Project Name: Ocean Delray

SITE PLAN REVIEW AND APPEARANCE BOARD

Meeting: February 27, 2019 | File No.: 2019-020-SPF-SPR-CLV | Application Name: Ocean Delray (1901 S. Ocean Blvd)

SITE PLAN REVIEW AND APPEARANCE BOARD STAFF REPORT

1 OVERALL SITE PLAN

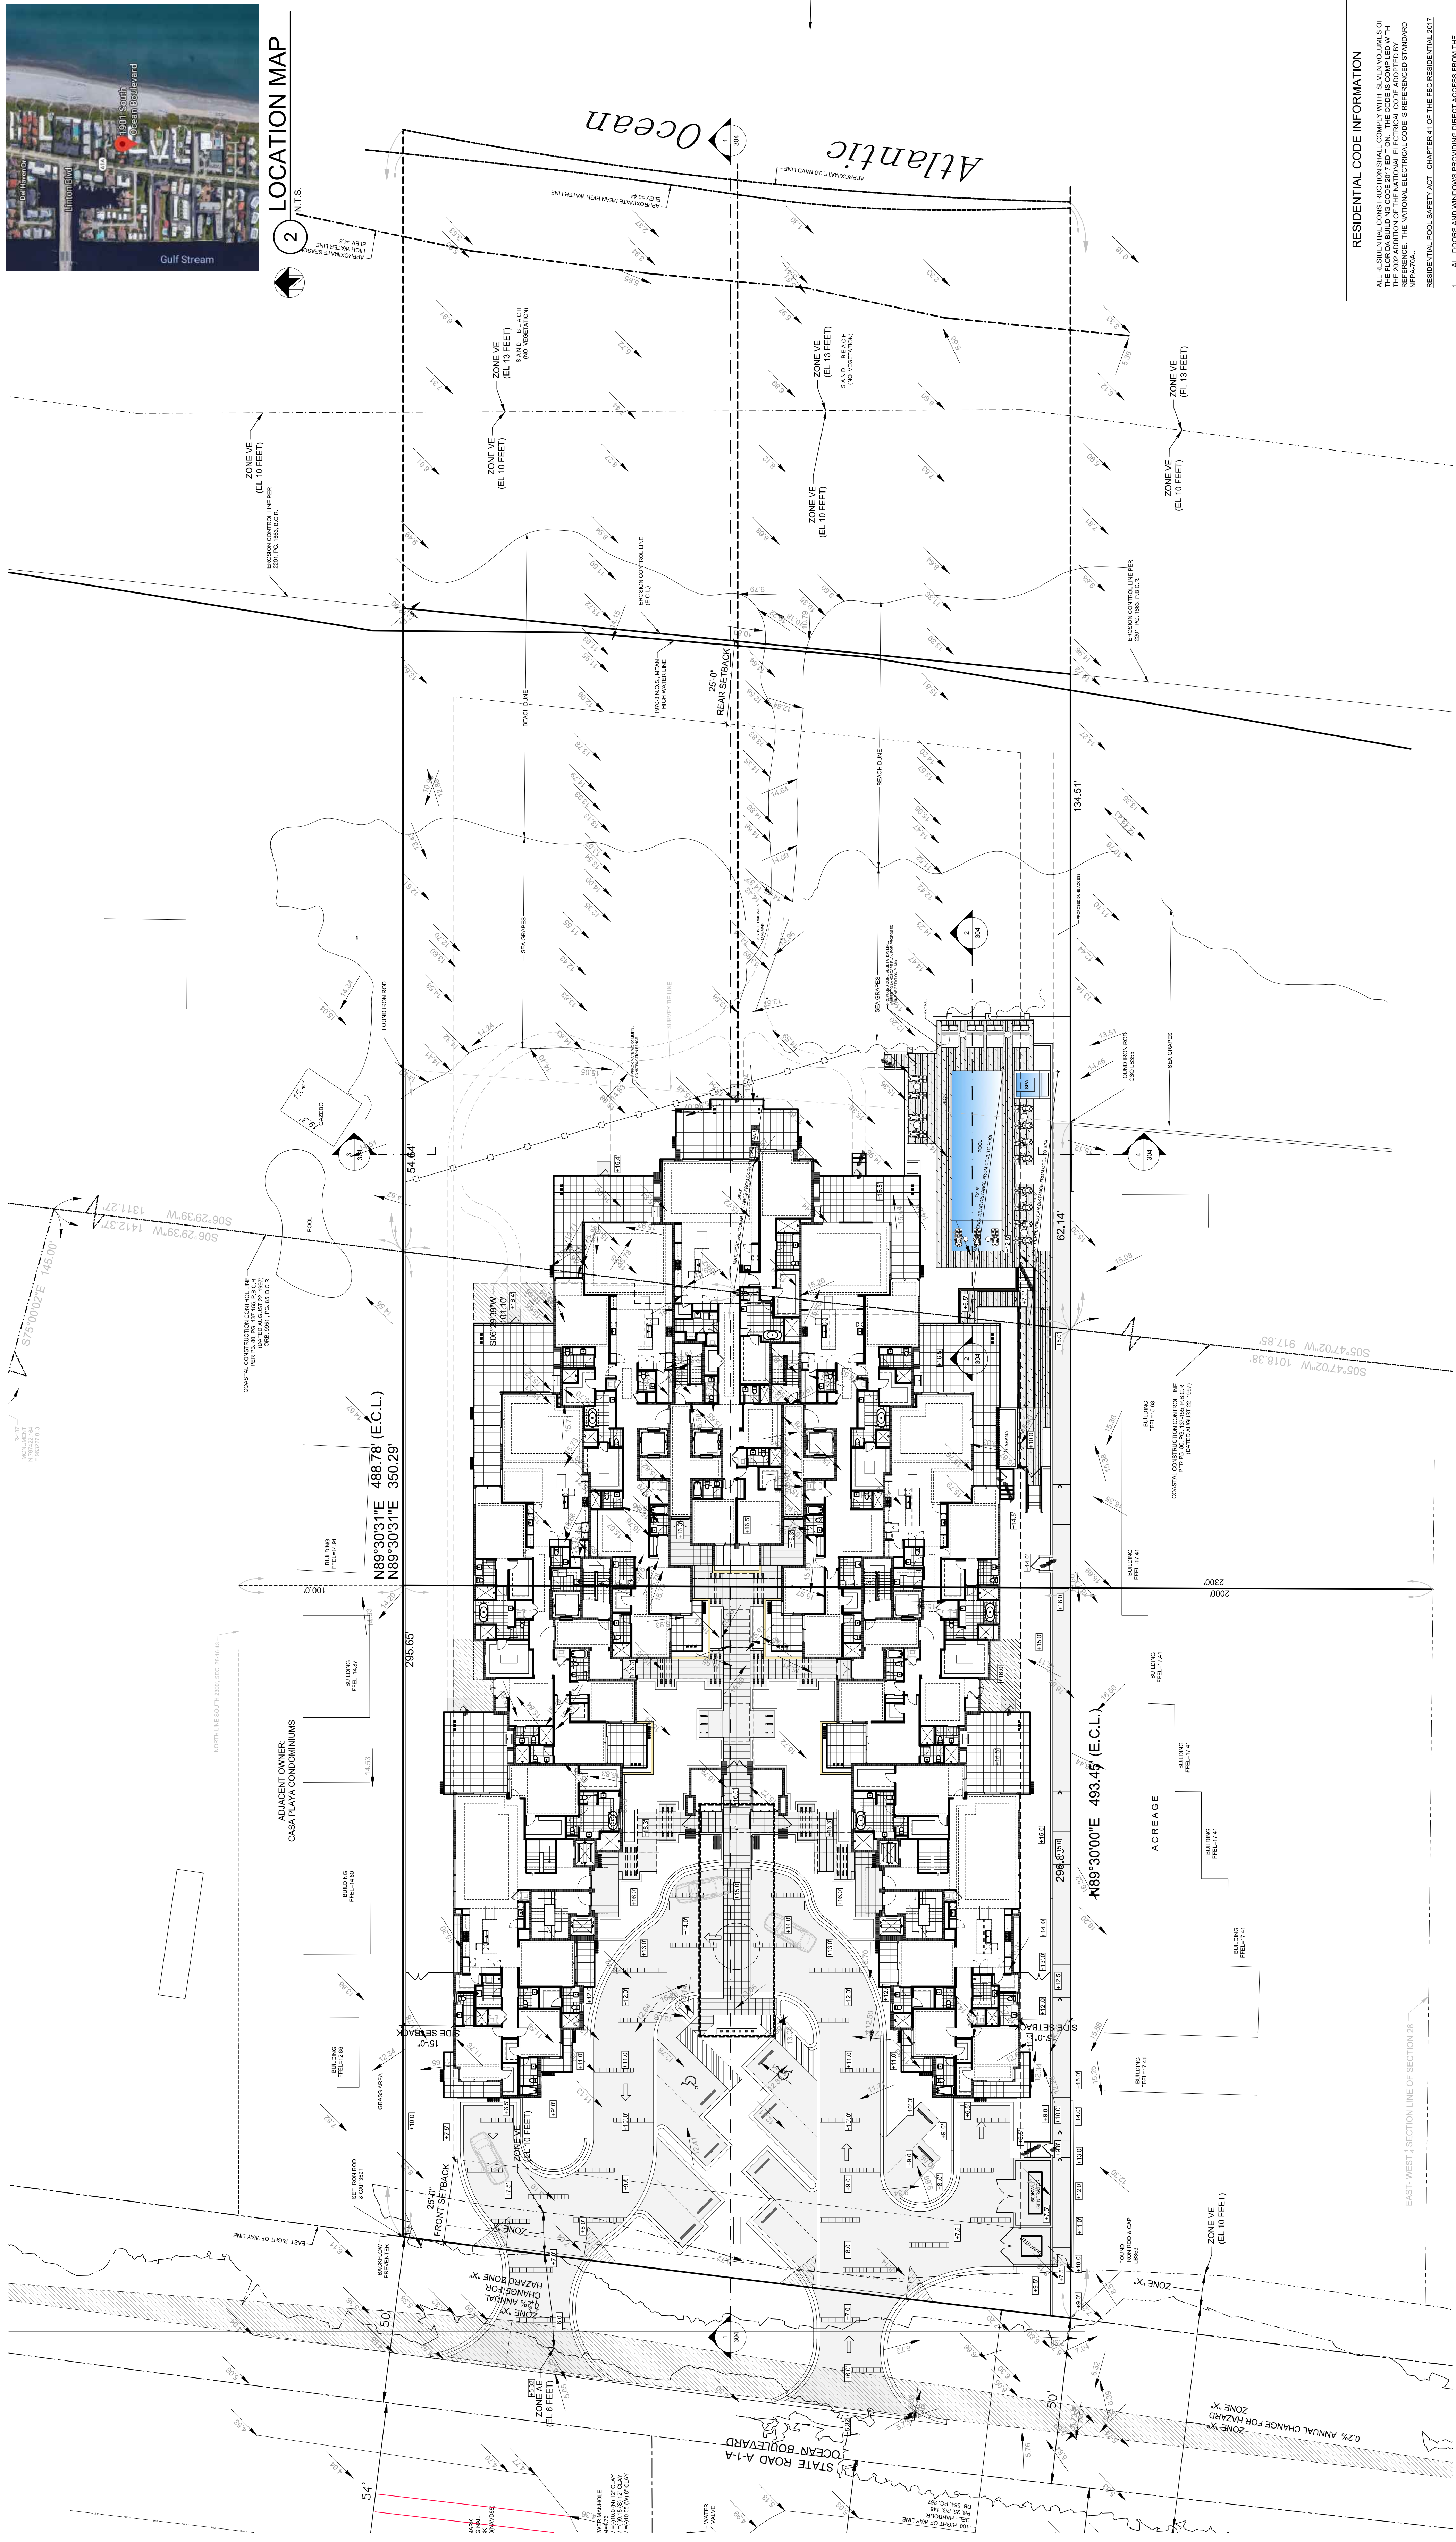
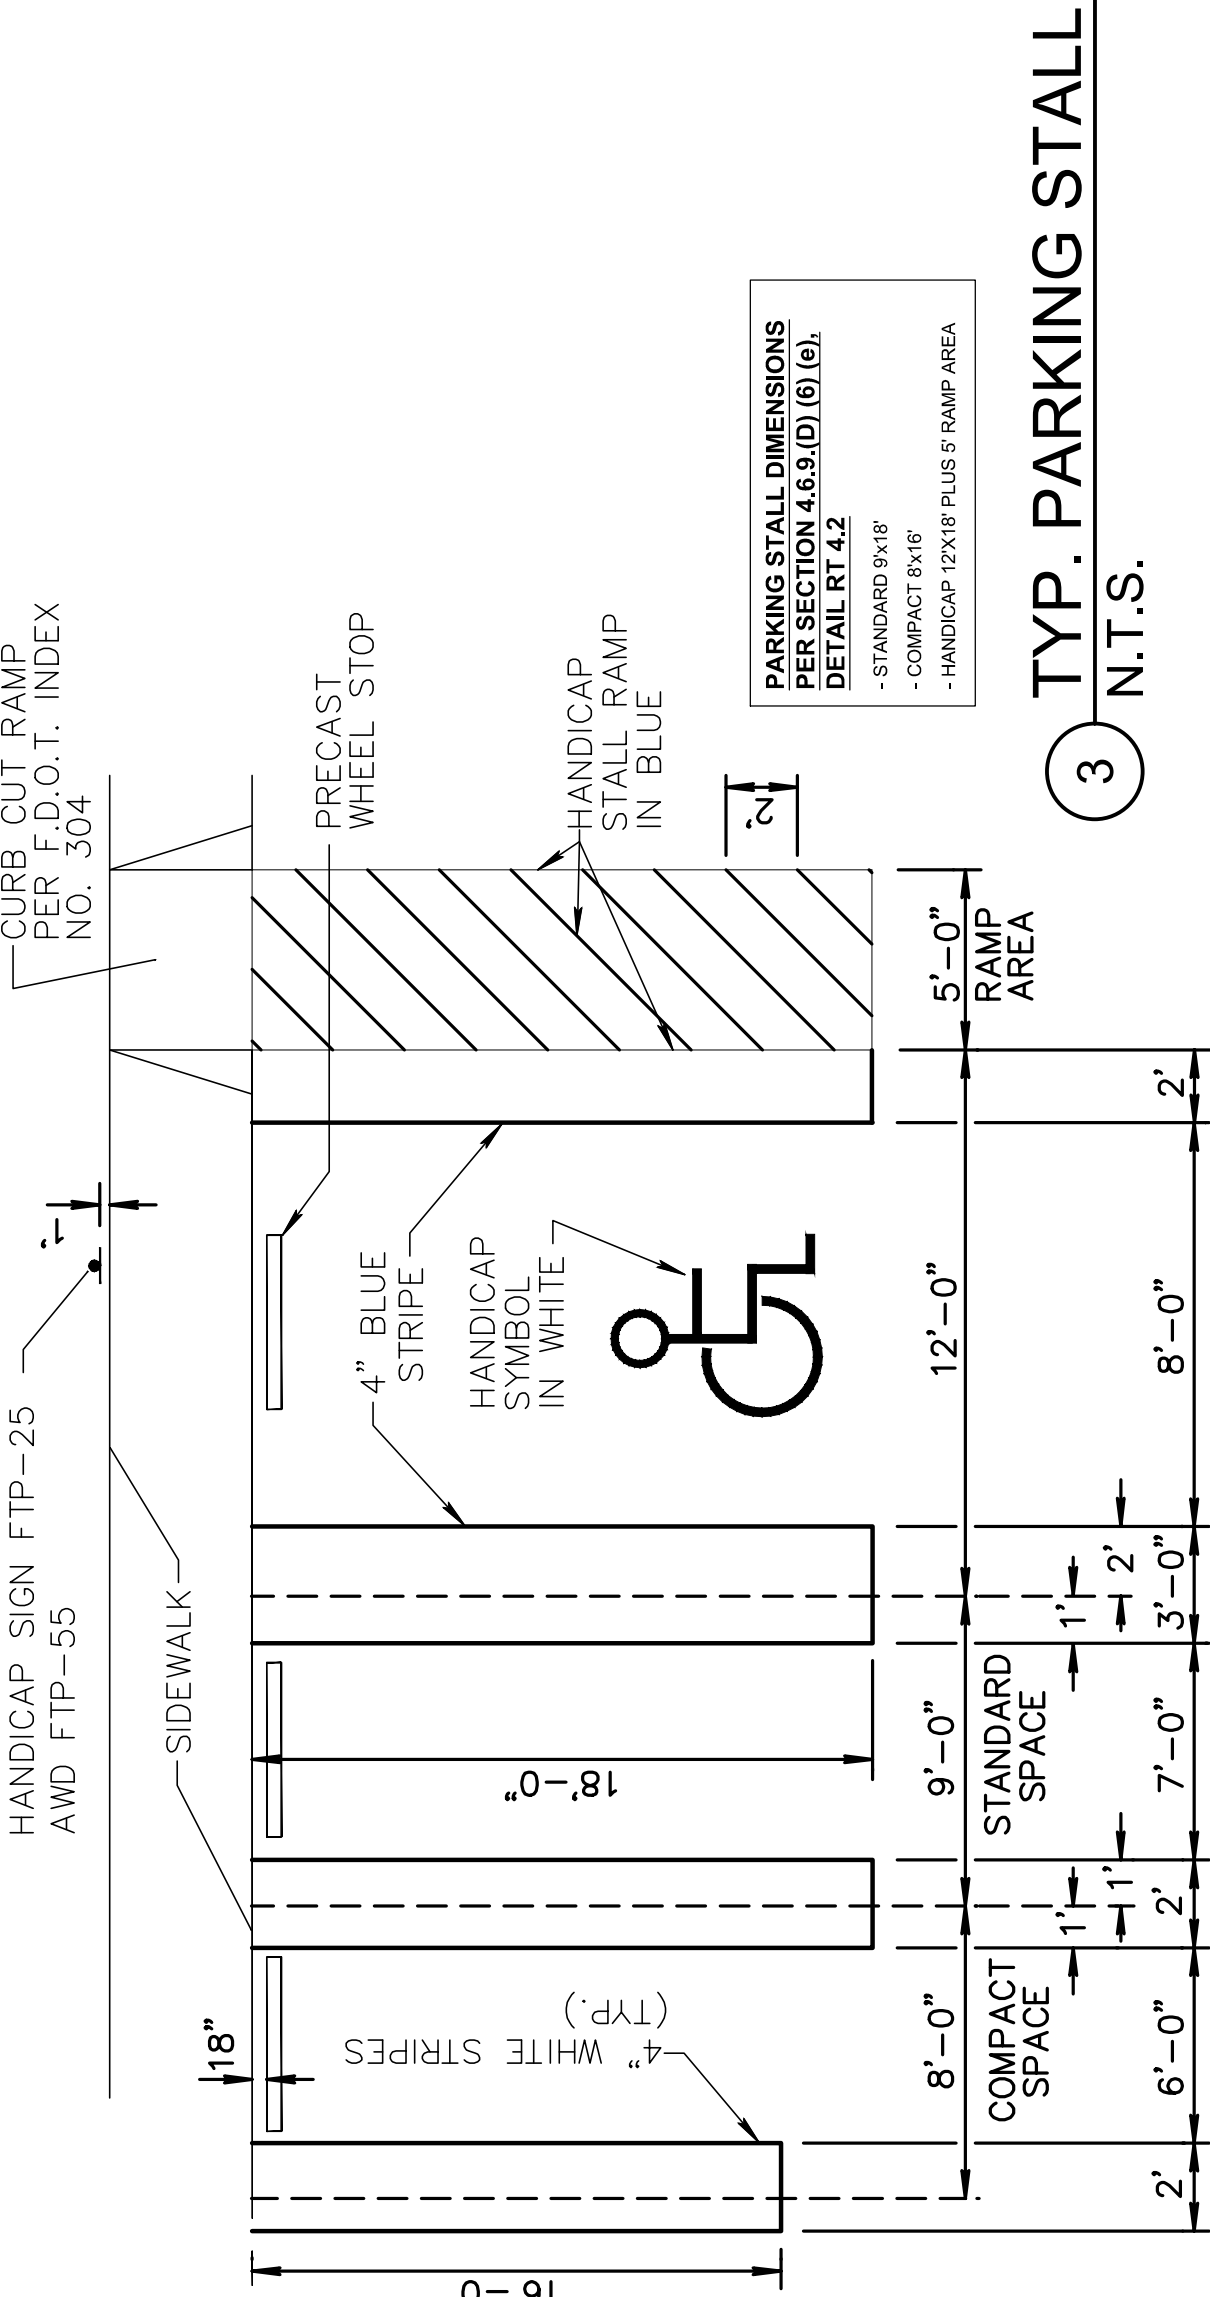
1. Provide FDEP and SFWMD approvals prior to building permit.
2. Provide revised plans reducing the patio size at unit 1 to 5' maximum within the side yard setback to the north prior to site plan certification.

3. Provide revised plans showing the elevation height of pool equipment above the Base Flood Elevation prior to site plan certification.
4. Provide revised plans relocating the generator outside of the front yard of the property in accordance to LDR section 4.3.3 (ZZ) prior to site plan certification.

7. Provide revised photometric plan showing the latest version of the floor plan layout prior to site plan certification.
8. Provide revised plans showing the SPA setback back at least 10' from the side property line prior to site plan certification.

- ✓ As shown on page A101, the distance between the parking spaces at the north and south entrances to A-1-A is approximately 35'. The 35' swale area provides for greater stacking distance to the first parking space from what is required in the LDR. Thus, complying with this requirement.
